DEPARTMENT OF TRANSPORTATION**National Highway Traffic Safety Administration**

[Docket No. NHTSA–2019–0105]

Denial of Motor Vehicle Defect Petition

ACTION: Denial of petition for a defect investigation.

Figure 1. Pre-crash operator control data, from top-to-bottom: vehicle speed, accelerator pedal position, brake pedal application, brake master cylinder pressure, and steering angle.

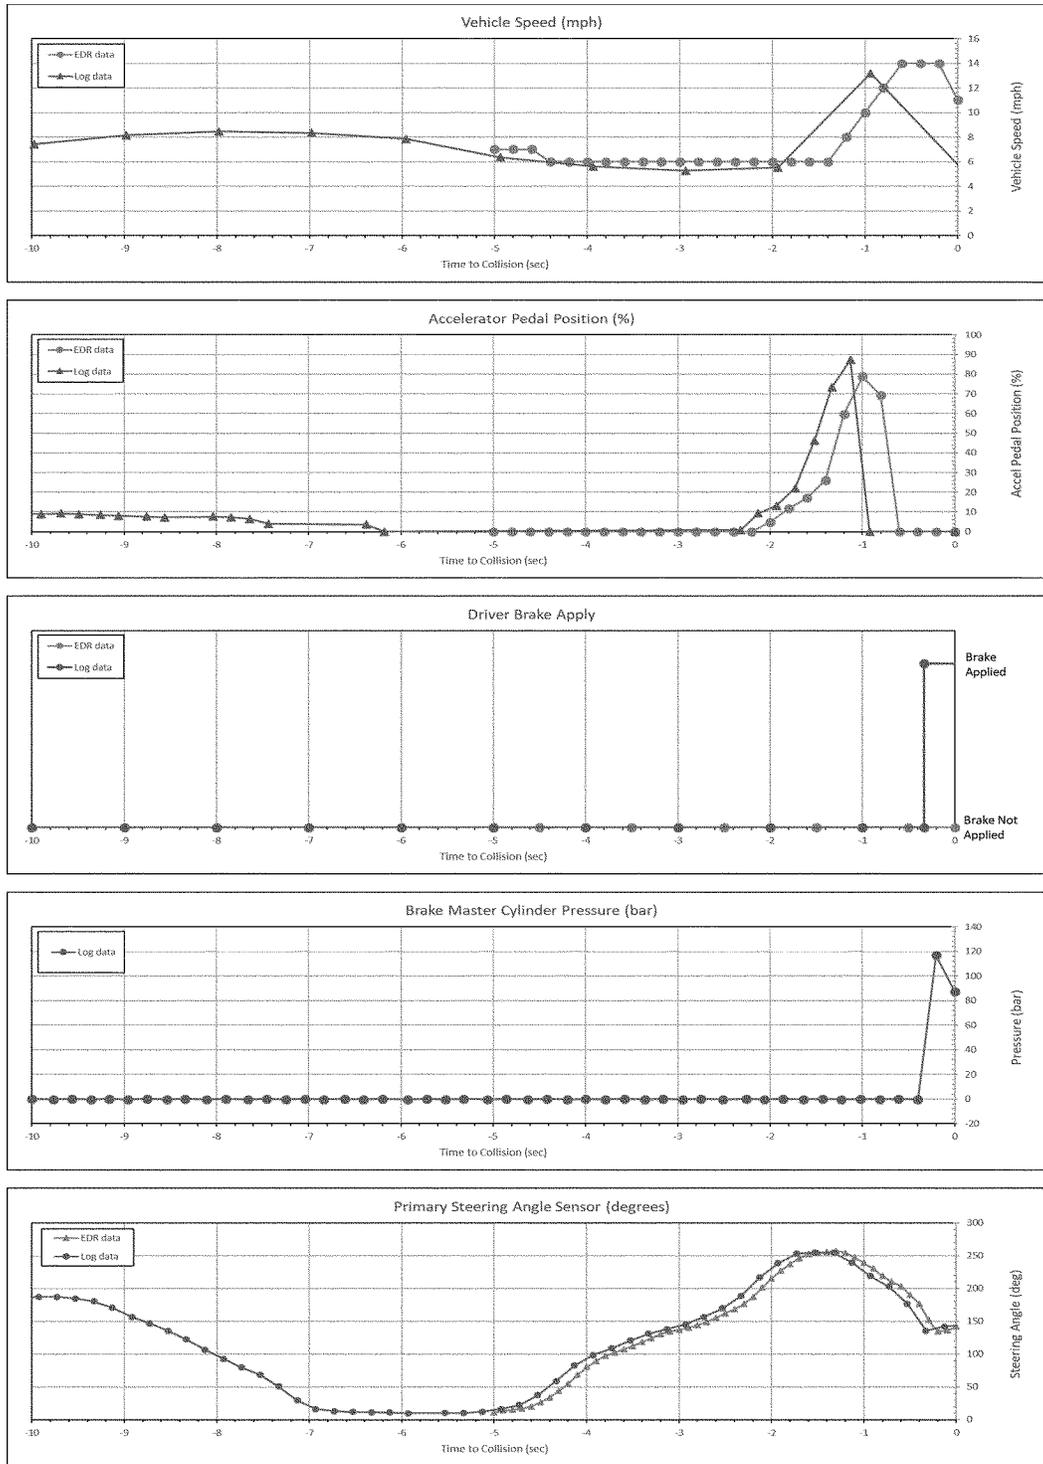
ODI's analysis of the subject crash event included reviews of vehicle log data, the EDR report furnished by the petitioner, statements from the driver, and a video of the incident provided by Tesla. This analysis confirmed the sequence of events described in Tesla's letter to the consumer. Figure 1 shows pre-crash vehicle speed and driver controls over the ten seconds prior to impact.

- The vehicle acceleration data used by Dr. Belt in his analysis was reported with the polarity reversed. In other words, the data shows the vehicle decelerating when it was accelerating and accelerating when it was decelerating. As shown in Figure 1, the vehicle first accelerates in response to a large accelerator pedal application, then decelerates in response to the late brake

- The evidence shows that the brake light switch functioned as designed in the event analyzed by Dr. Belt (see Figure 1).
- The ESC and Traction Control systems cannot request positive torque in the subject vehicles.
- The APPS data recorded in the EDR report and data log show the physical position of the accelerator pedal (see section 3.5 System Safeguards). There is no other source for the accelerator pedal data.
- The vehicle does not veer to the left at any point during the crash event (see Figure 1 and section 3.3.4 ODI Analysis of Event Video File).
